River Fly- In Condominium
 Unit: 510

Report By: Tyler Sparks

03/02/2022

Framing

1.04-Anchor bolts are installed per plans/code.

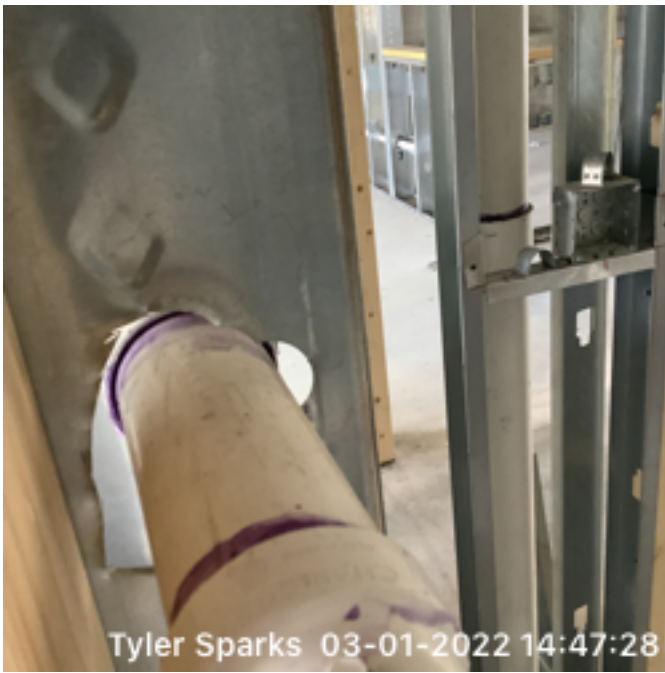
S - Satisfactory, the system meets plan/code/manufactures specifications

NOTE: Pin shot
